October 28, 2015

SUBJECT: Comments on the Bay Delta Conservation Plan Partially Recirculated Draft Environmental Impact Report/Supplemental Draft Environmental Impact Statement

SUBJECT: Comments on the Bay Delta Conservation Plan and Environmental Impact Report/Environmental Impact Statement

Figure 1. Projected Inflow to Trinity, Shasta, Oroville, and Folsom Reservoirs – NAA, NAA-ELT and NAA-LLT

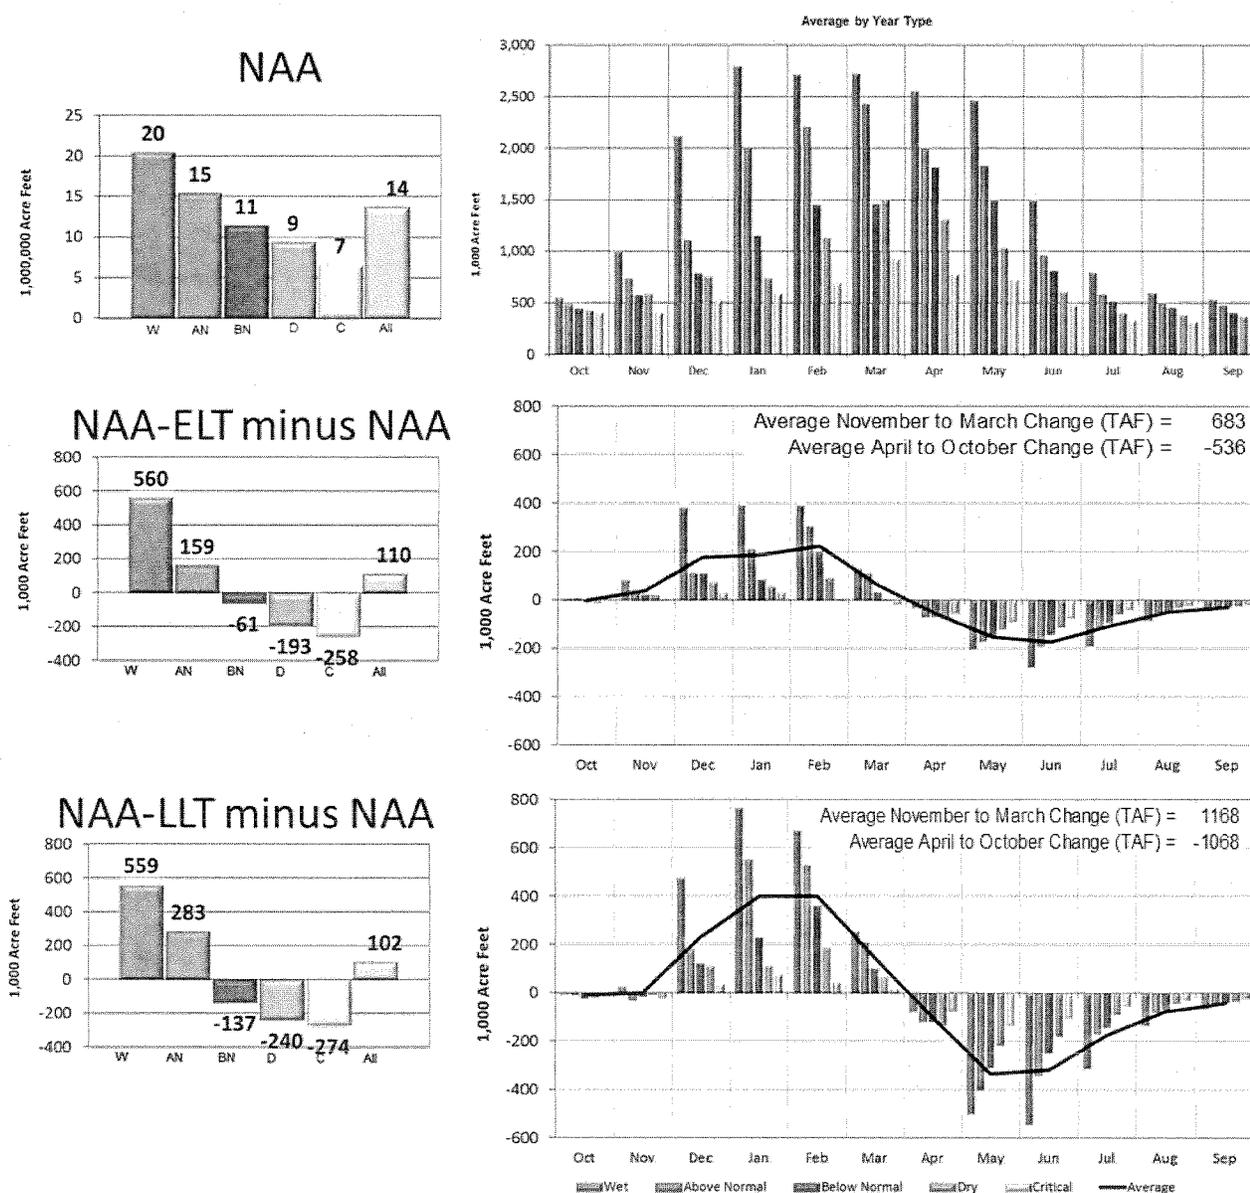
The significance of changed hydrology between the three without project baselines is illustrated in Figure 1 below. The figure illustrates the projected combined inflow of Trinity, Shasta, Oroville, and Folsom Reservoirs under the three NAA baselines. Numerous modeling projections for climate change have been developed, and in this BDCP group of Scenarios Trinity, Shasta, and Oroville inflow are projected to increase overall, but with a

In our opinion, the CalSim II depicted operations that incorporate climate change are not reasonably foreseeable and do not represent a likely future operation of the CVP/SWP. Although an argument is typically made that these study baselines will be used in a comparison analysis with Project Alternatives tiering from these baselines, we believe that the depicted operations do not represent credible CVP/SWP operations and we have no confidence in the results and they are inappropriate as the foundation of a Project Alternative. As such, although the modeling approach may provide a relative comparison between equal foundational operations, we are apprehensive to place much confidence in the computed differences shown between the NAA and Project Alternative Scenarios.

Figure 2. Projected Shasta Reservoir Carryover Storage, NAA, NAA-ELT and NAA-LLT

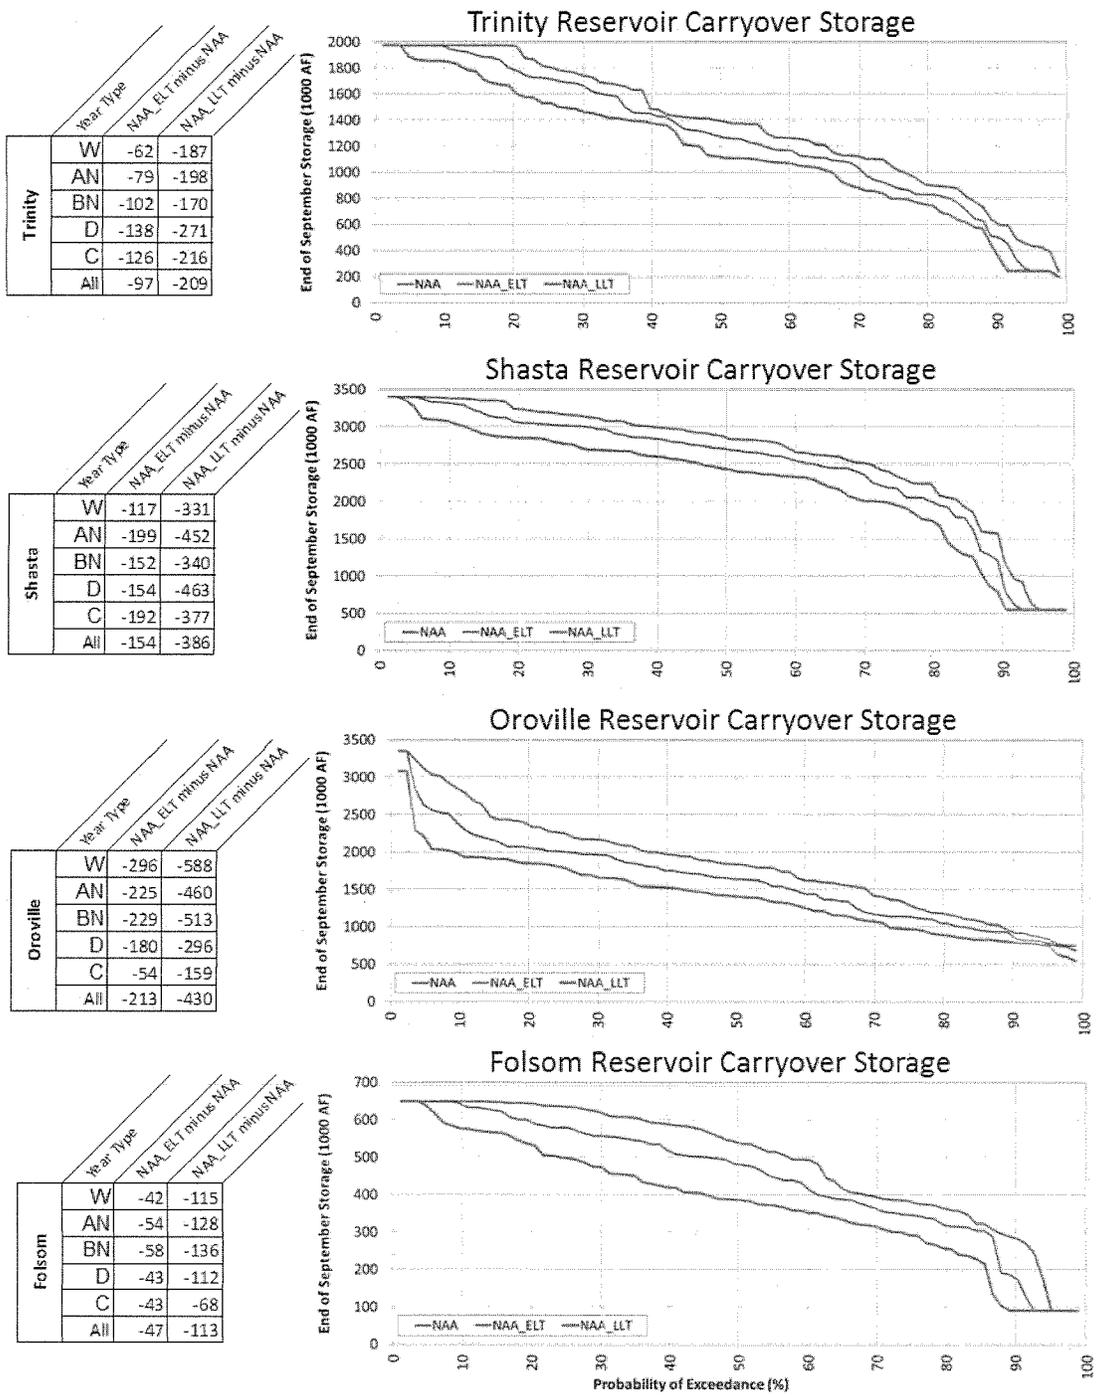
For upstream CVP and SWP reservoirs the assumed shift of inflows due to climate change (Figure 1) along with a continuing need to satisfy exports demands significantly affects carryover storage. The CVP and SWP simply cannot satisfy water demands and regulatory criteria imposed on them in the NAA-ELT and NAA-LLT modeling scenarios.

Figure 2 illustrates the typical change in carryover storage as shown for Trinity, Shasta, Oroville, and Folsom Reservoirs. The relatively high frequency (approximately 10% of time) of minimum storage occurring at CVP reservoirs illustrates our questioning of credible operations in the studies.

Figure 3. Projected Inflow to Millerton Lake –NAA, NAA-ELT and NAA-LLT

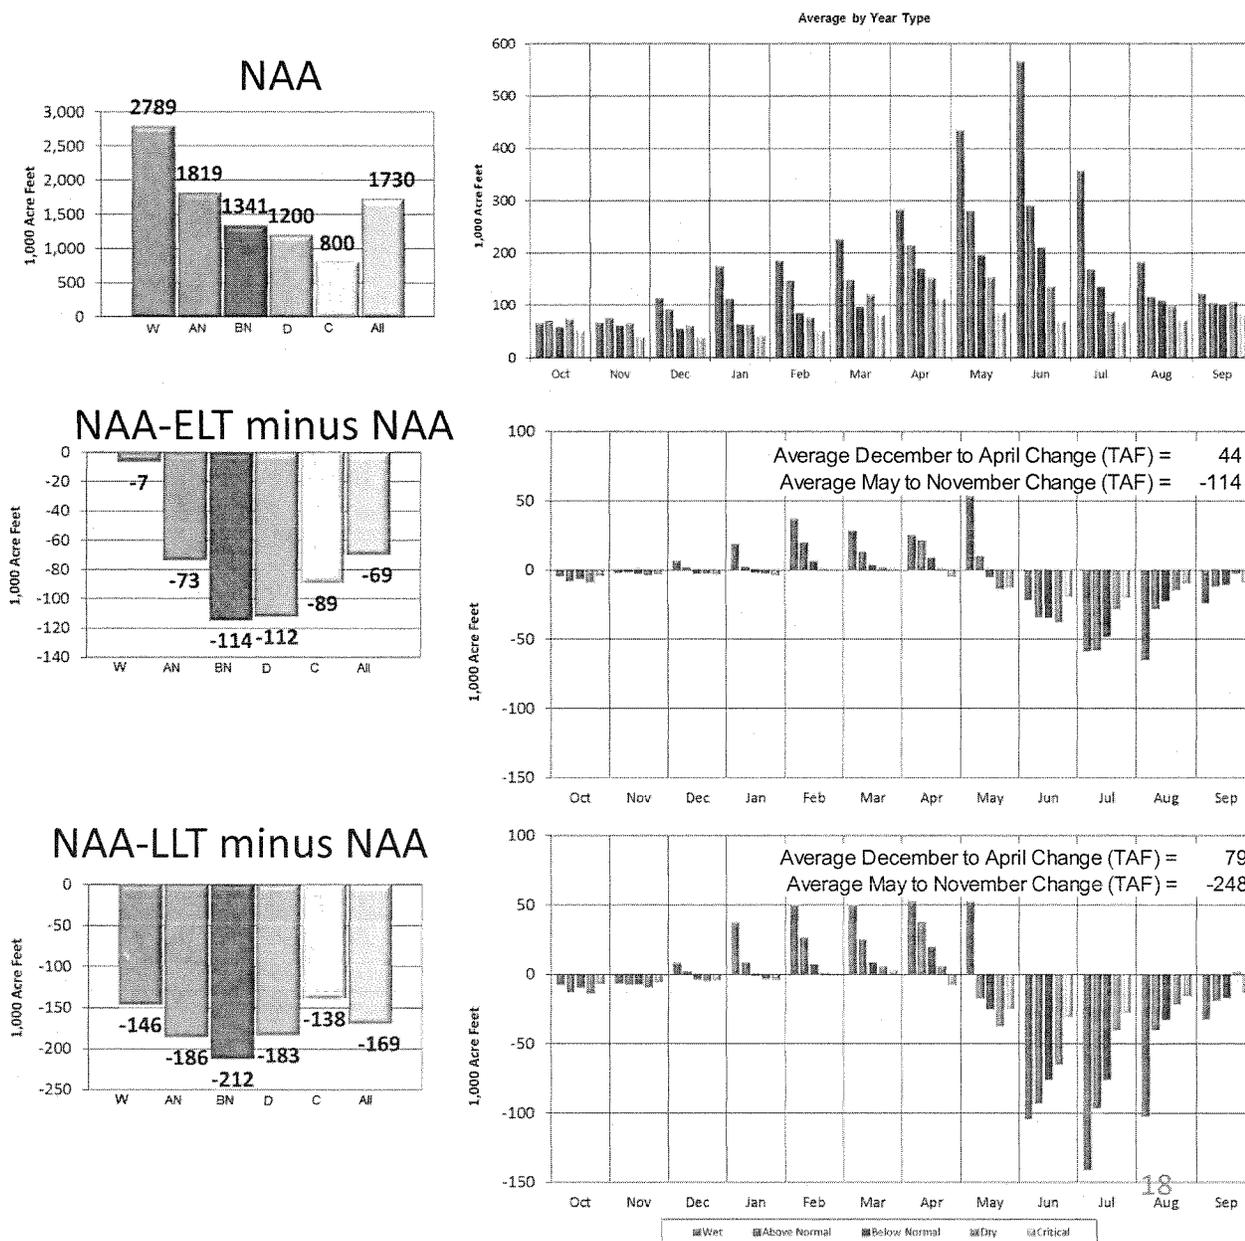
San Joaquin Valley reservoirs are depicted with an overall decrease in annual runoff with some shifting of runoff from spring to winter, but mostly just decreases in spring runoff due to a decline in snowmelt runoff during late spring⁵. Figure 3 illustrates the assumed effects of climate change upon inflow to Millerton Lake.

The hydrology differences imposed in the NAA Scenarios of the Friant Division are described above, and its appropriateness may be subject to additional debate and Alternative assumptions. However, our review found that implementation of Millerton Reservoir inflow as affected by climate change was improperly performed.

Figure 4. Millerton Reservoir Carryover Storage, NAA, NAA-ELT and NAA-LLT Scenarios

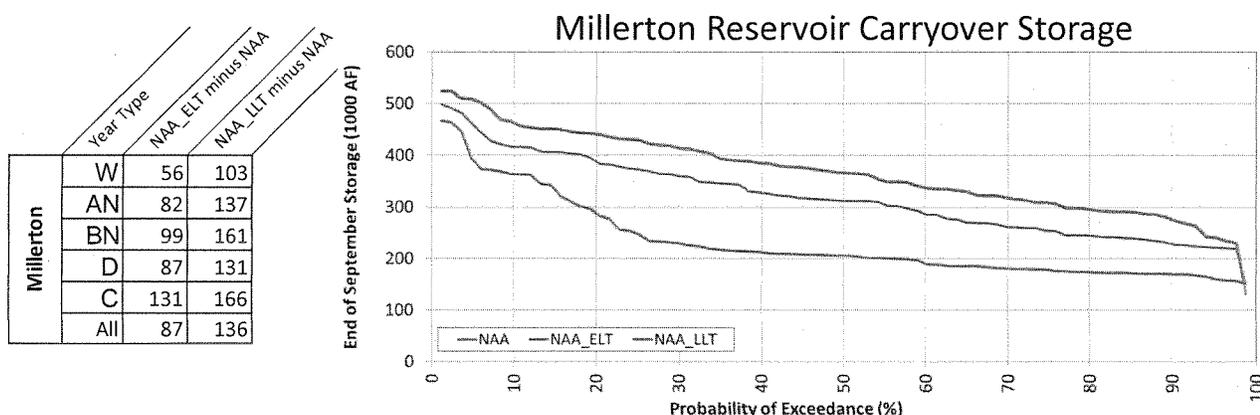
Inflow to Millerton Reservoir in this version of CalSim is input in three separate time series for purposes of depicting the hydrology of potential upper basin reservoirs. Climate change hydrology was inconsistently incorporated at Millerton Reservoir and misapplied to the water supply and flood control operations. The result is an unrealistic operation for river releases and canal diversions. Figure 3 illustrates the projected ELT and LLT changes in Millerton Reservoir inflow incorporated in these studies. On face value of the input data, regardless of Friant Dam river release assumptions the effect of climate change at Millerton Lake will affect water deliveries.

Evidence of the inconsistent inflow problem is shown in the result for the comparison of carryover storage of Millerton Reservoir under the NAA, NAA-ELT, and NAA-LLT Scenarios (Figure 4). Carryover storage is higher in the ELT and LLT Scenarios due to climate change effects to inflow incorporated in reservoir operations but not in the computation of water supply deliveries. Thus, water deliveries are suppressed and the reservoir ends the year with greater storage.

Figure 12. Temperature Exceedance Sacramento River at Bend Bridge Existing, No Action Alternative, ELT

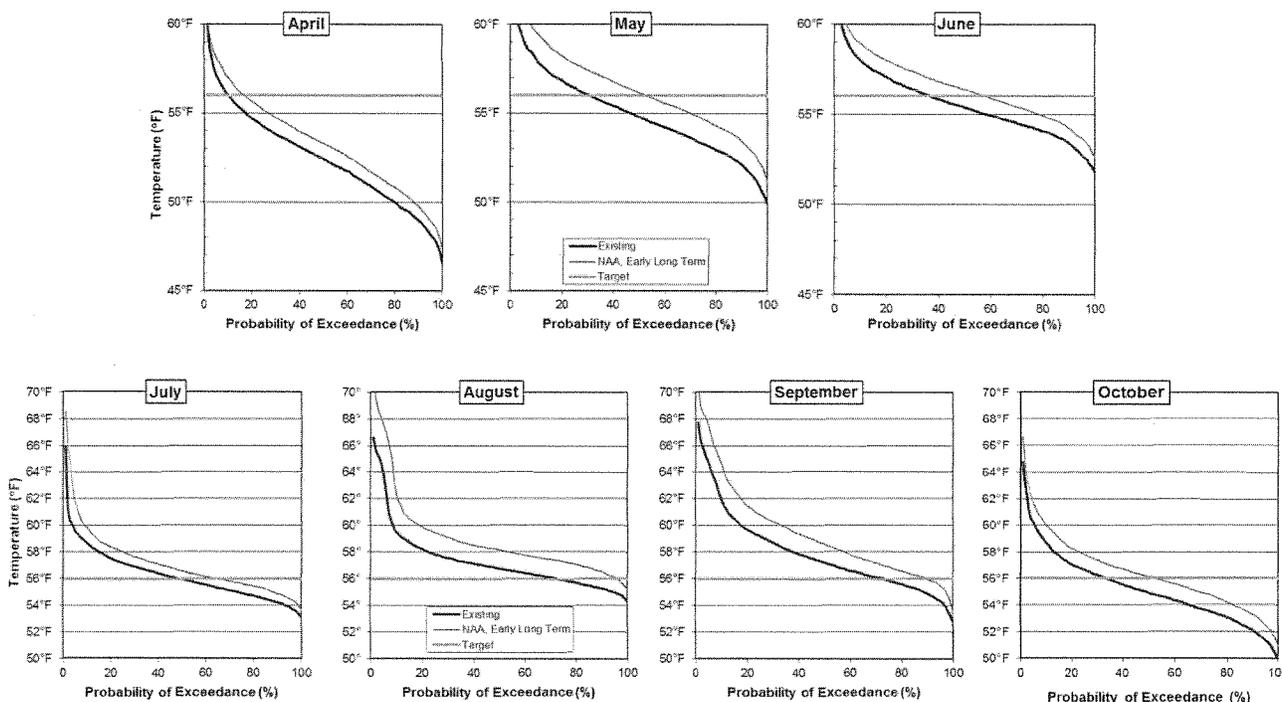
The increase in equilibrium temperatures combined with decreases in storage would lead to water temperature conditions that would likely not achieve the assumed objectives. Figure 12 and Figure 13 illustrate an increase in the probability that a water temperature target of 56°F would be exceeded at Bend Bridge under both the NAA-ELT and NAA-LLT Scenarios. The probability of exceedance increases approximately 5% to 20% depending on the month for the NAA-ELT Scenario and approximately 10% to 40% for the NAA-LLT Scenario.

Figure 19. NDD, Bypass Requirement, Bypass Flow, and Excess Sacramento R. flow for Alt 4-ELT

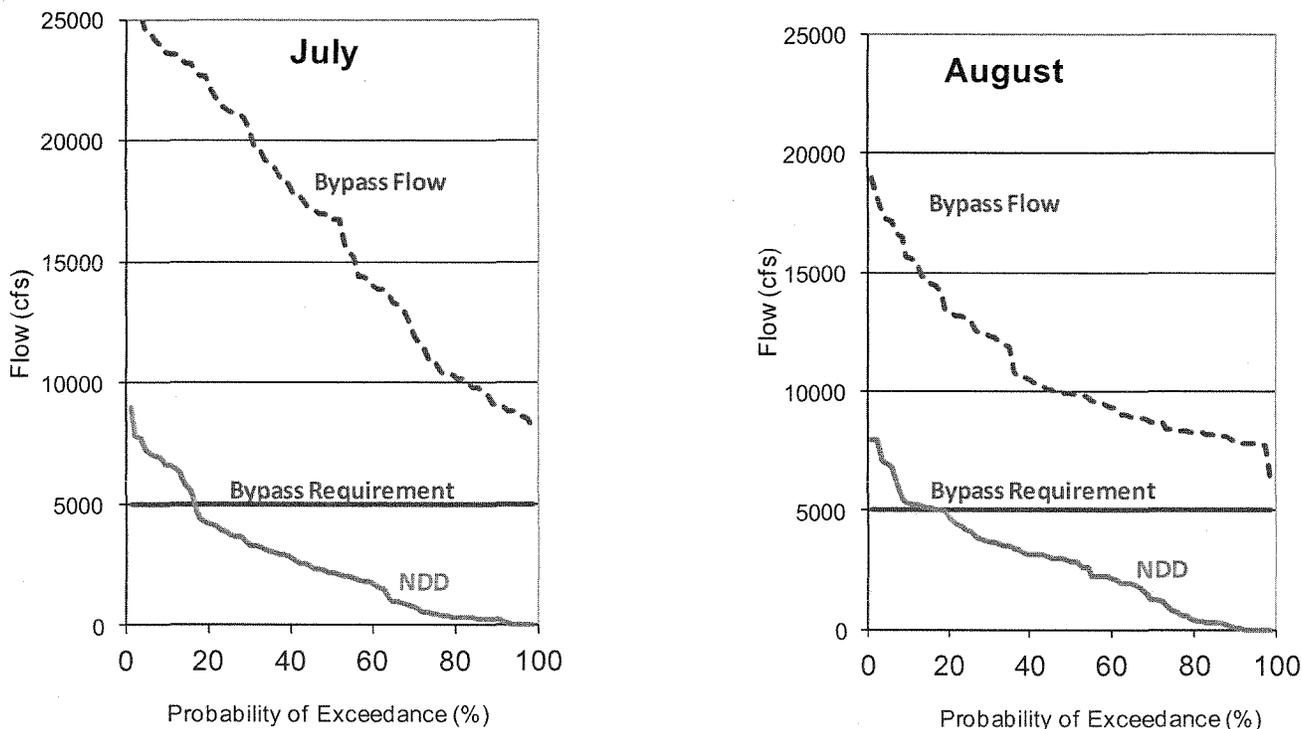
Sacramento River flow below the North Delta Diversion (NDD) must be maintained above the specified bypass flow requirement, therefore the NDD rates are limited to the Sacramento River flow above the bypass requirement. Due to an error in CalSim II that specifies an unintended additional bypass requirement, modeling performed for the BDCP EIRS often bypasses more Sacramento River flow than is specified in the BDCP project description. This error has been fixed in the most recent public releases of CalSim II, but BDCP modeling has not been updated to reflect these fixes. Figure 19 contains exceedance probability plots showing the Sacramento River required bypass, Sacramento River bypass flow, NDD, and excess Sacramento River flow to the Delta as modeling for BDCP. As can be seen in Figure 19, the bypass flow is always above the bypass requirement in July and August. The BDCP version of CalSim sets a requirement for Sacramento River inflow to the Delta needed to satisfy all Delta flow, quality, and export requirements, this requirement should be removed when modeling the NDD.

Figure 22. Alt 4-ELT North Delta Diversion Versus South Delta Diversion for July, August, and September

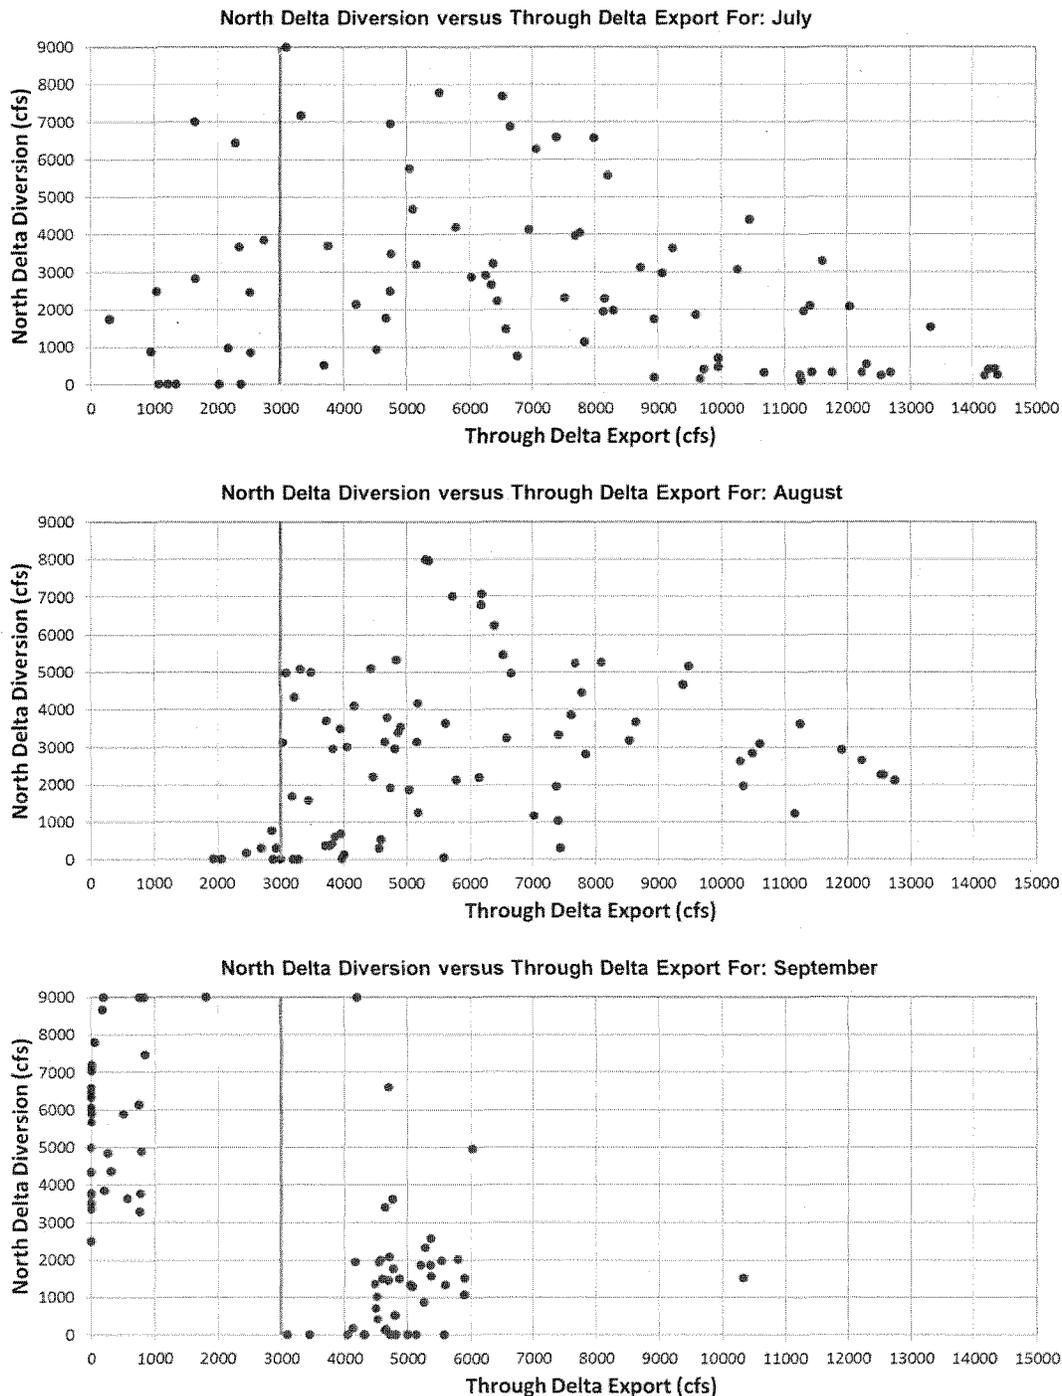
Figure 22 contains figures for July, August, and September for Alt 4-ELT that plot NDD against SDD. In the months of July to September SDD are occasionally very high, exceeding 14,000 cfs in July, with minimal NDD. This occurs due to outdated model code that imposes an instream flow requirement in Sacramento River flow below Hood in excess of the bypass criteria prescribed in the BDCP. There are numerous occurrences when bypass flows prescribed in the BDCP are exceeded and SDD are higher than expected. On the other hand, there are also many times when NDD are above minimum pumping levels and SDD are below the BDCP prescribed 3,000 cfs threshold indicated by the green line in Figure 22. For unknown reasons, the model code requiring SDD to be greater than 3,000 cfs before NDDs occur from July through September is deactivated in the BDCP modeling of this Alternative.

Figure 23. South Delta Diversion at Banks

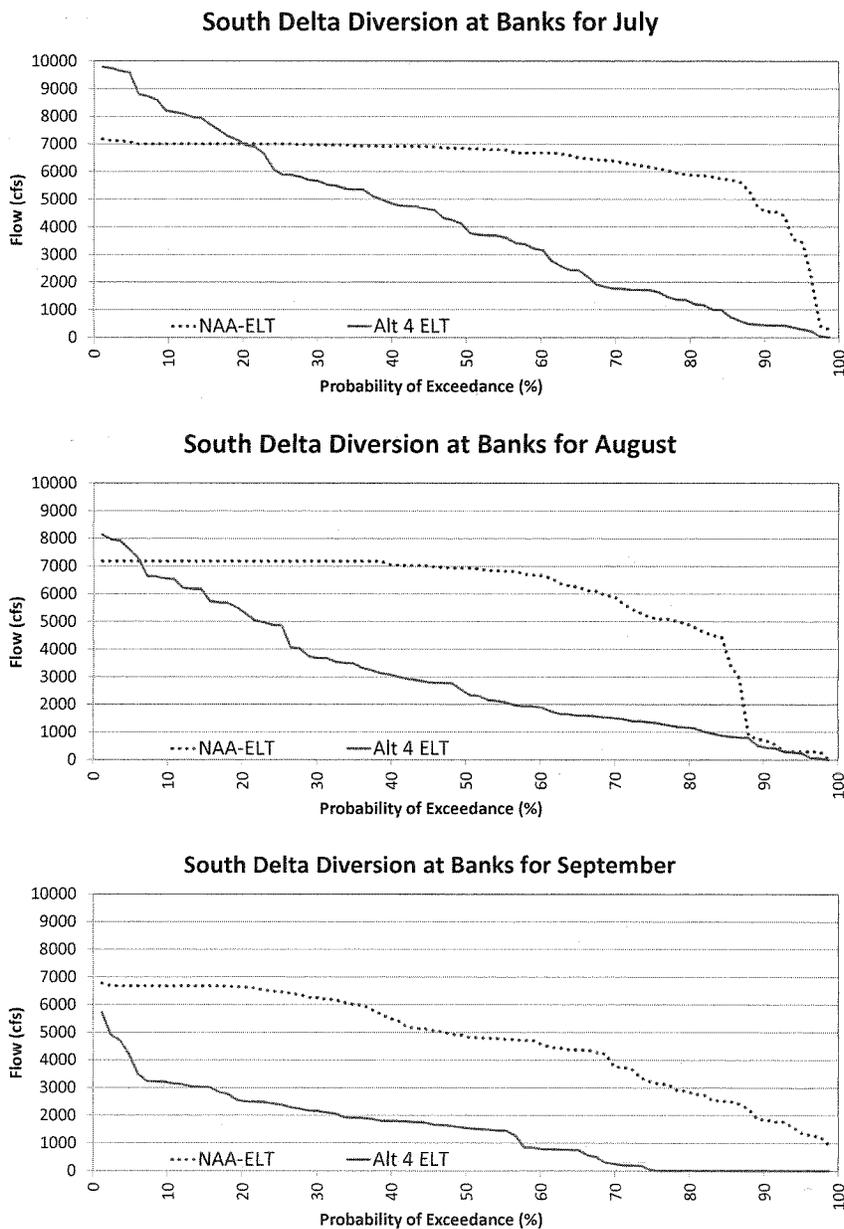
South Delta Diversion at Banks is not limited to existing permit capacity of 6,680 cfs and pumping may reach full capacity of 10,300 cfs in July, August, and September. Figure 23 contains exceedance probability charts of South Delta Diversion at Banks for July, August, and September. The chart for July shows SDD at Banks exceeding existing permit capacity 20% of years, in August this occurs in about 7% of years. There are South Delta diversions at Banks 25% of the time in September while diversions from the Sacramento River may range from 2,500 cfs to 7,500 cfs.
